SUBJECT: CASTAWAY ISLAND KAYAK CHANNEL DREDGING

SUBJECT: Castaway Island Kayak Channel Dredging
BID# CF-0125-22
Contract 72021-22 PO 647533-22

CITY OF JACKSONVILLE
DEPARTMENT OF PUBLIC WORKS
ENGINEERING DIVISION
CONSTRUCTION CHANGE ORDER

Change Order No. Two (2) Date February 28, 2023

MAP SHOWING HYDROGRAPHIC SURVEY OF:

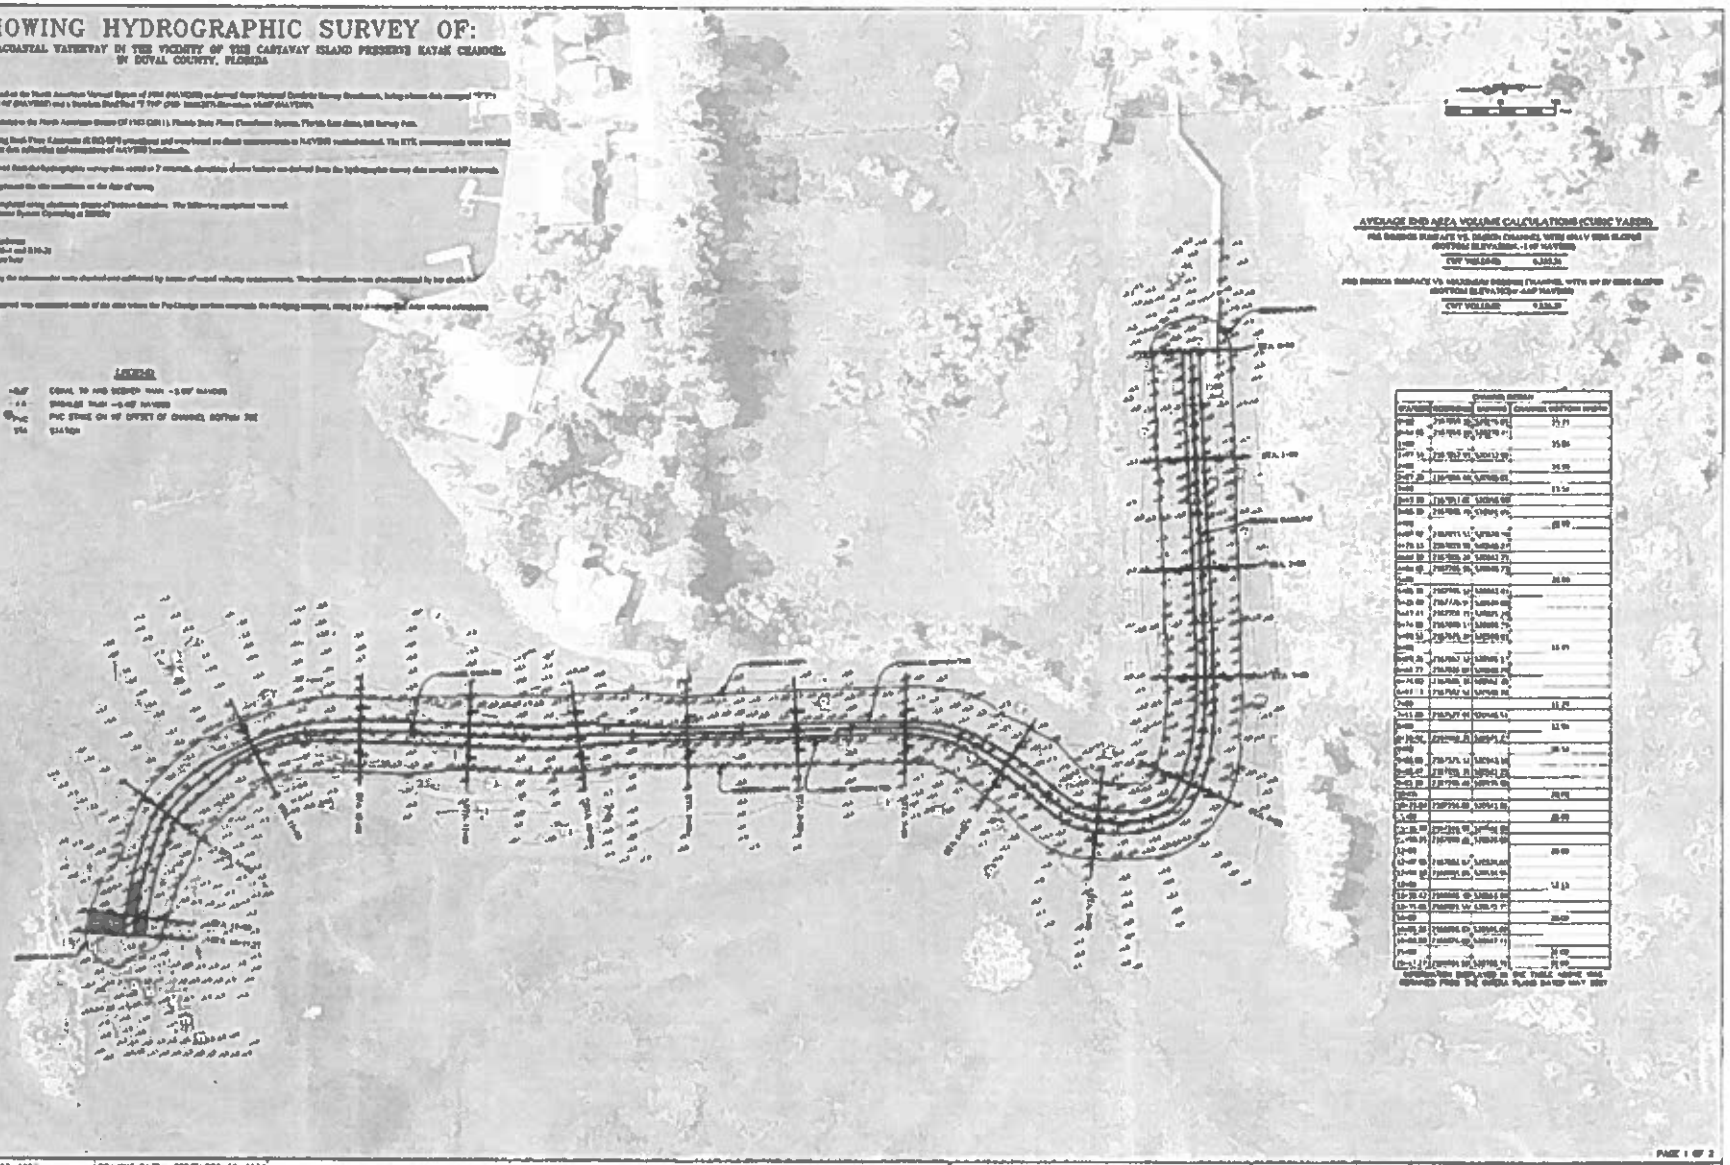
Bid item	MASTER ITEM DESCRIPTION	Adjusted Quantity	UOM	Unit Cost	ADDITION	NET DELETION
	Additional Scope					
4	Dredged Material located beneath the floating dock and kayak lauch	318.00	CY	$62.00	$ 19,716.00

Justification: After the contractor removed the dredge material per the design (pre-survey qty 9,826 CY), there was remaining sediment heaped beneath the floating dock and kayak launch, creating an unlevel and unsafe walking surface for pedestrians. Park requested the removal of the sediment to eliminate the hazard and allow the floating dock and kayak launch to function as intended per the manufacture design.
